TRANS/WP.29/710

World Forum for Harmonization of Vehicle Regulations (WP.29)

DRAFT SUPPLEMENT 1 TO THE 05 SERIES OF AMENDMENTS TO REGULATION No. 14

(Safety-belt anchorages)

DUMMY SPECIFICATIONS */

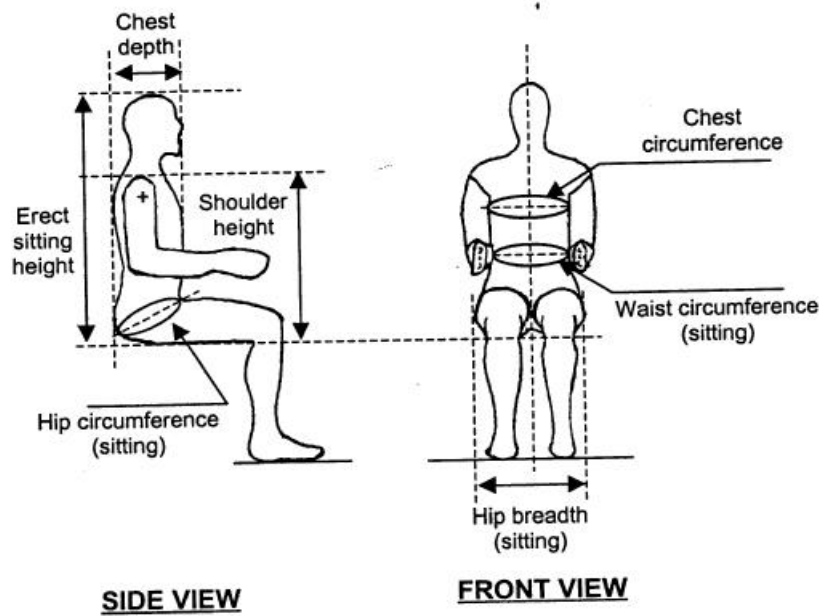
Mass	97.5 ± 5 kg
Erect sitting height	965 mm
Hip breadth (sitting)	415 mm
Hip circumference (sitting)	1200 mm
Waist circumference (sitting)	1080 mm
Chest depth	265 mm
Chest circumference	1130 mm
Shoulder height	680 mm
Tolerance on all length dimensions	± 5 per cent

Remark: a sketch explaining the dimensions is given in the figure below.
